February 24, 2023

Re: General Order (GO) 112-F Gas Inspection of PG&E's Operations and Maintenance (O&M) plans, Emergency plans, Design and Construction standards, and Part 191 related plans

Pacific Gas and Electric Company (PG&E) submits this response to the SED's inspection report stemming from the inspection of PG&E's O&M plans, Emergency plans, Design and Construction standards, and Part 191 related plans. The inspection took place from January 9 through January 13, 2023, and on January 27, 2023, the SED submitted their inspection report. The SED identified three (3) concerns, below is PG&E's response to the SED inspection report.

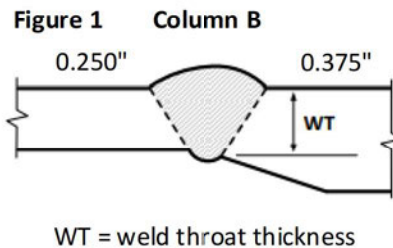
SED reviewed PG&E's TD-4160P-51 "Welding Procedure Selection - API 1104 Procedures" that PG&E provided pursuant to GSRB's pre-audit data request #33. In TD-4160P-51, section 1.4, Figure 1. Thickness Determination for Dissimilar Wall Thickness Joints, the selection of wall thicknesses for joining dissimilar wall thickness joints, is very vague and unclear. There is no recourse in determining the welding process used in the weld. The samples provided are not labeled with any of the approved welding process. The samples are also not labeled with the grade of pipe or the individual wall thickness. This makes the selection of the proper wall thickness to use for further welding process selection nearly impossible.

SED recommends labeling the dissimilar wall thickness samples in TD-4160P-51, section 1.4, Figure 1 with proper pipe grades and wall thicknesses in order for the correct welding procedure to be followed.

**PG&E's Response:** PG&E appreciates SED's recommendation but believes the labeling recommendation by SED is impractical to implement in Figure 1 of TD-4160P-51, Section 1.4 due to the number of combinations in pipe grade and wall thickness at each joint. TD-4160P-51, Section 1 references Table 1, which provides a direct correlation to those possible combinations. As described in the procedure summary for TD-4160P-51 shown below the process outlined in TD-4160P-51 includes six steps that must be followed to determine the appropriate welding procedure specifications to apply.

TD-4160P-51 provides steps to select the correct weld procedure specification (WPS) according to the required variables of the joint to be welded. Every section in TD-4160P-51 coincides with a column in Table 1, "WPS Selection Matrix," and provides instruction to the user on how to select the proper variable. Section 1.4 applies to Column D, Applicable wall thickness, and the excerpt of Figure 1 below shows how to determine the applicable wall thickness based on the engineered joint design. For example, when joining 0.250" to 0.375" the correct wall thickness to use in Table 1 would be determined per Figure 1, "Column B" (weld throat thickness).
